Mayfield Manchester: Phase 1, Republic
Planning Statement Addendum

June 2023

- 1.1 This Planning Statement Addendum (herein referred to as the “Statement”) accompanies an application for a variation of condition under Section 73 of the Town and Country Planning Act 1990, to amend Planning Permission Ref 125248/FO/2019 (as amended by 134907/NMC/2022 and 135956/NMC/2023) in respect of Plot M within the Mayfield Strategic Regeneration (SRF) area. The Site is 0.49 hectares and is located to the north of the Mancunian Way and south of Mayfield Park. The application is submitted to Manchester City Council by Mayfield Republic Limited (the “Applicant”).

Figure 2.1 – Comparison of 2019 (left) to 2023 proposal (right), with alternative option (middle)

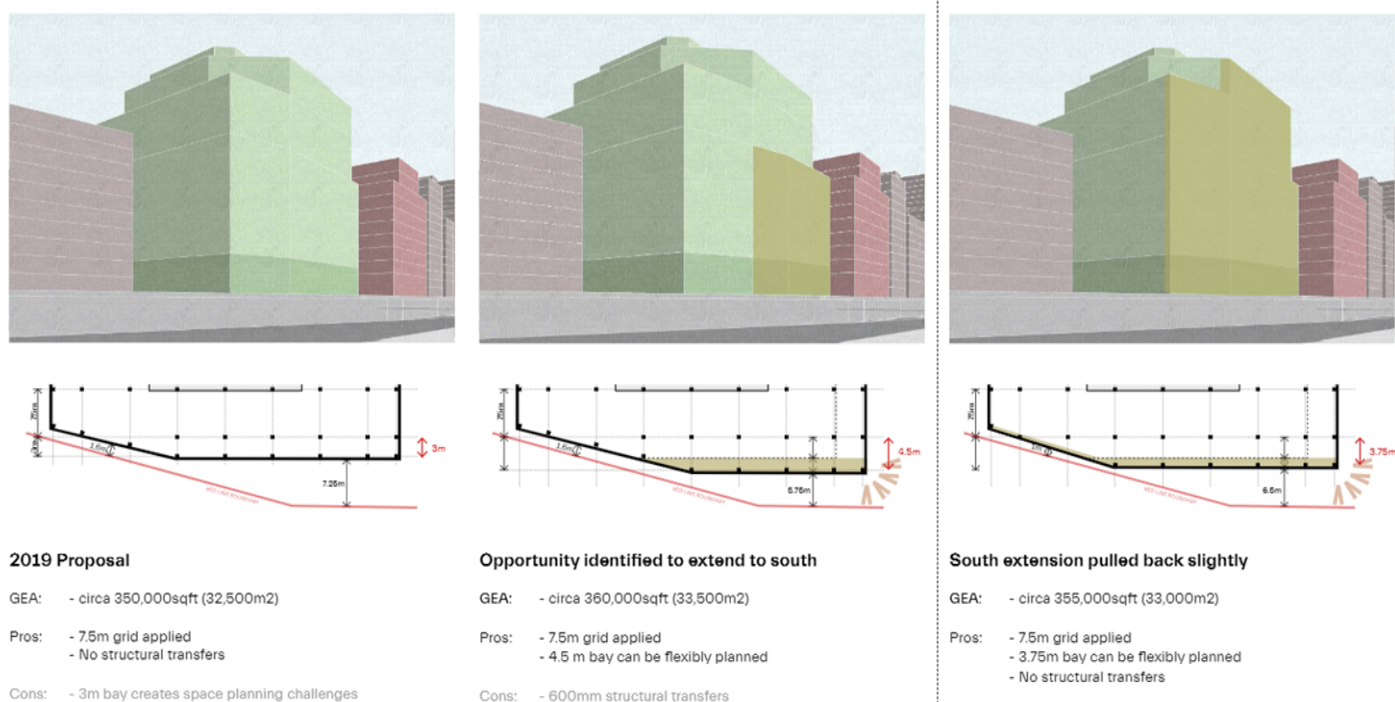
- 2.5 Alterations to the massing on the southern elevation better respond to the new structural grid, removing the requirement for transfer structure and improving the embodied carbon performance of the superstructure. In addition, the resultant increase in net internal area (NIA) helps to offset the cost uplift of the enhanced environmental measures to be incorporated into the building, supporting the scheme's commercial viability.
- 2.6 The proposed massing has been defined through extensive options analysis to determine the optimum structural solution and building form. This massing approach also helps to provide a better visual address to the communities to the south, namely Ardwick. Similarly, the park facing aspects are emphasised by the chamfered envelope, directing long ranging views across Mayfield Park and provided tenants with a variety of dynamic spaces to occupy.

Figure 2.2 approved ground floor plan versus proposed ground floor plan

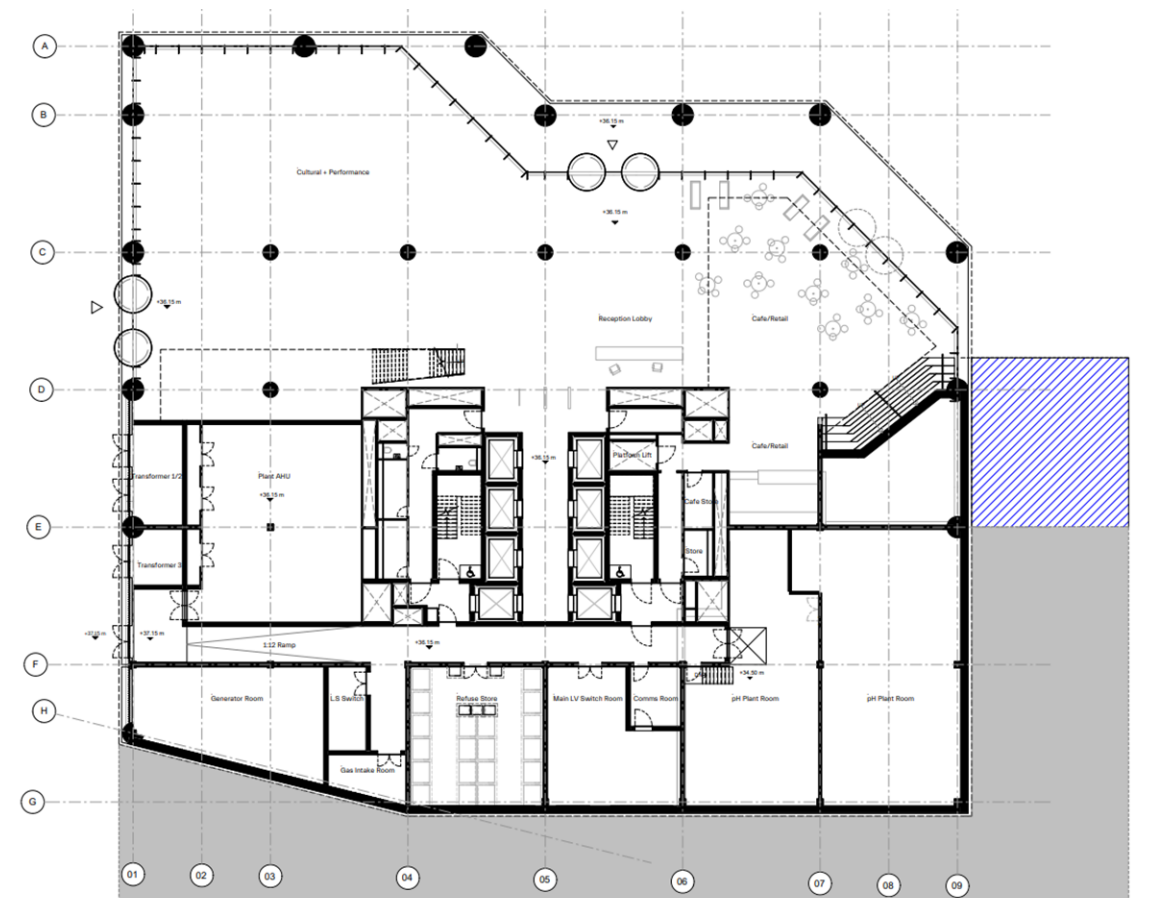
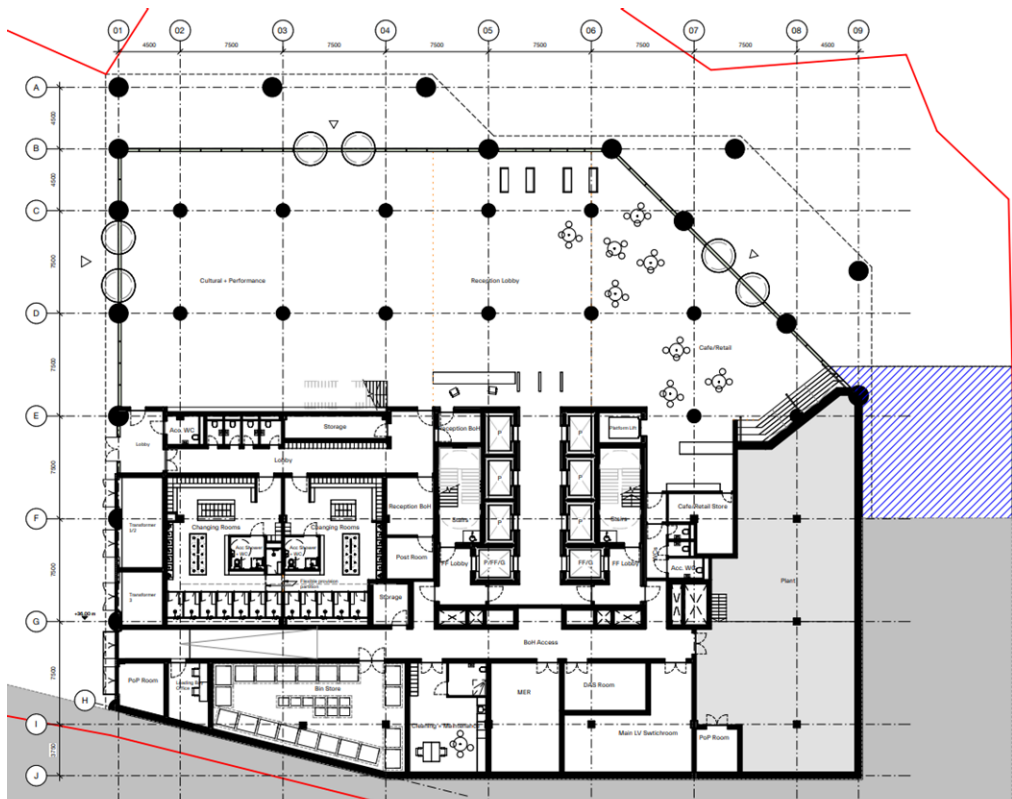
- 2.13 A revised approach to massing, driven by maximising efficiencies in the structural grid, has also required a shift in the location of the core of the building. This newly positioned core directly aligns with the columns required to support the building structurally, placed more centrally within the floorplan.
- 2.14 As such, internal areas and particularly those at ground level, have had to be amended to maximise the efficiency, flexibility, and quality of the internal space. Correspondingly, the entrances at ground floor have been repositioned to align with these revised internal layouts. A plan of the approved and proposed ground floor level is provided below to highlight the difference.
